**Fossil Rock Mine**

Re: Abatement Action for Citation #211730, Fossil Rock Resources, LLC, Permit Number C/015/0009

Please find enclosed with this letter an amendment to the Fossil Rock Permit to address the Abatement Action for Citation #211730. The amendment includes calculations and text associated with ditches and diversions at the waste rock site.

### **APPENDIX C-1 – ADDITIONAL DIVERSION DITCH DETAILS**

Figure 2: Additional Ditch DA Configurations

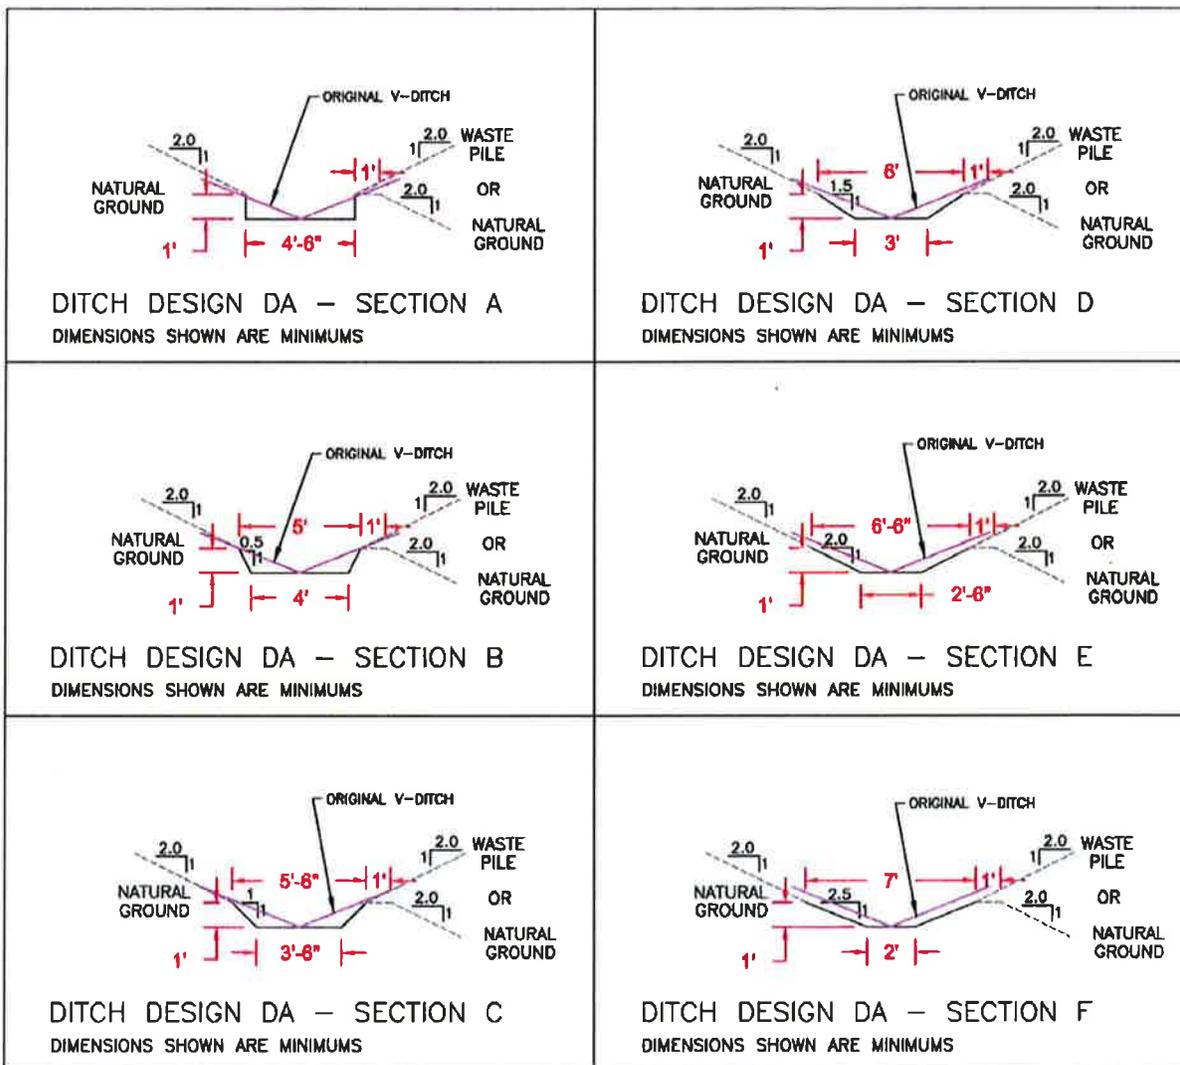
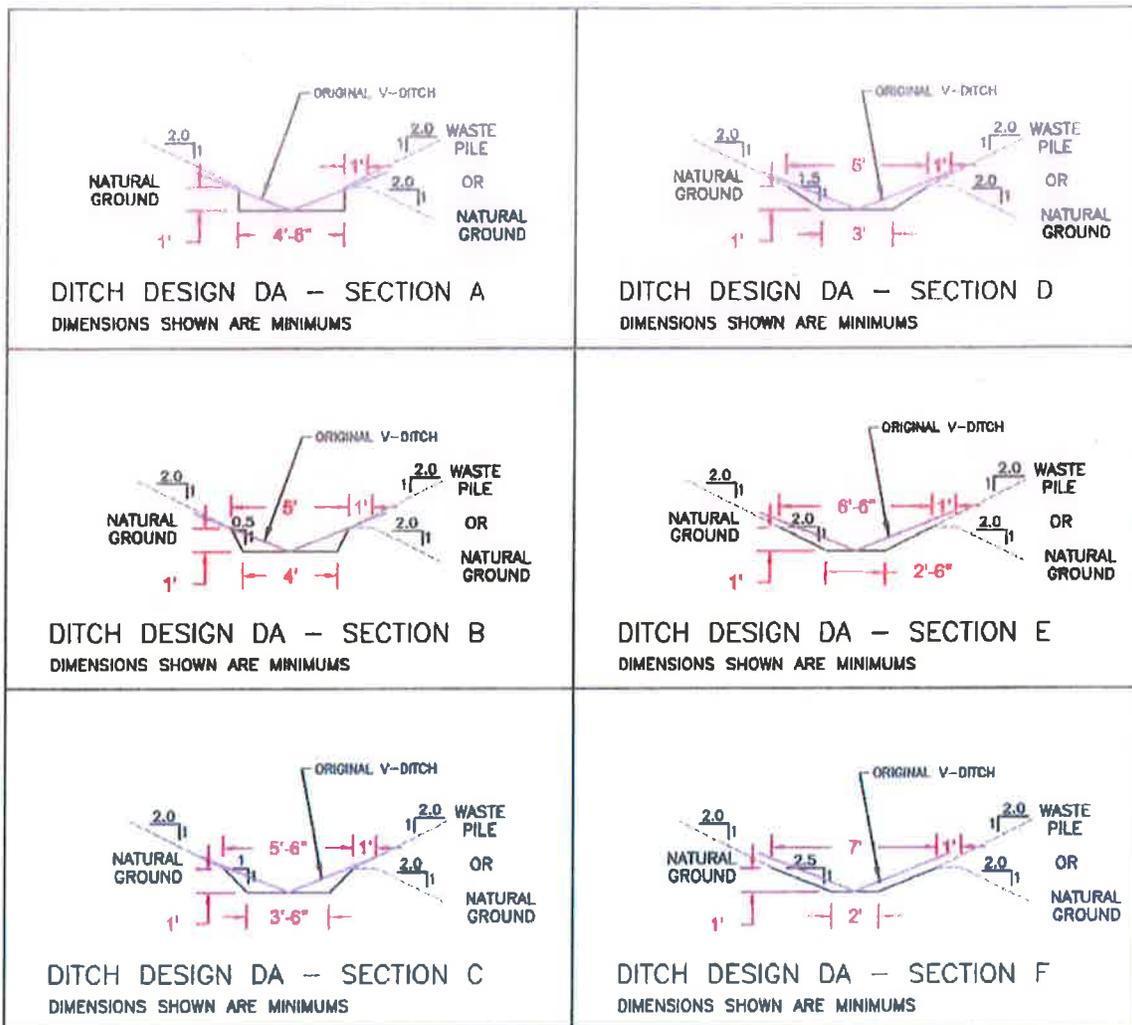
This section is included as a supplement to the original design engineer's analysis and is intended to provide the site operator with additional options for the final cross-sectional shape of diversion Ditch DA. The need for the additional configurations are a result of both the operational difficulties associated with maintaining a v-ditch and the propensity of the native, unconsolidated fill material to reach the natural angle of repose.

In an effort to reduce erosion each ditch configuration is designed with a maximum mean velocity of five feet per second. Additional Ditch DA cross-sections will be trapezoidal and unlined. These ditch configurations will be applicable for the entire ditch length until it approaches the pond where the slope increases from 2 to 18%. At that point, a wide, rip-rap lined trapezoidal ditch, as detailed on drawing sheet number CM-10830-WB will be used.

The original design parameters and methodologies will remain unchanged. Manning's number is 0.035, channel slope is 2%, maximum mean velocity is five feet per second, and the minimum design flow for each ditch configuration is 18.9 cubic feet per second. The ditch capacity is calculated for each shape as follows.

Figure 2 presents the additional ditch configurations that are acceptable to use at the waste rock storage site.

| Description | Water Depth | Side Slope, | Channel Base | Flow Velocity | Discharge |
|-------------|-------------|-------------|--------------|---------------|-----------|
| Section A   | 1.00        | 0.0         | 4.50         | 4.7           | 21.15     |
| Section B   | 1.00        | 0.5         | 4.00         | 4.8           | 21.74     |
| Section C   | 1.00        | 1.0         | 3.50         | 4.8           | 21.53     |
| Section D   | 1.00        | 1.5         | 3.00         | 4.6           | 20.92     |
| Section E   | 1.00        | 2.0         | 2.50         | 4.5           | 20.18     |
| Section F   | 1.00        | 2.5         | 2.00         | 4.3           | 19.42     |
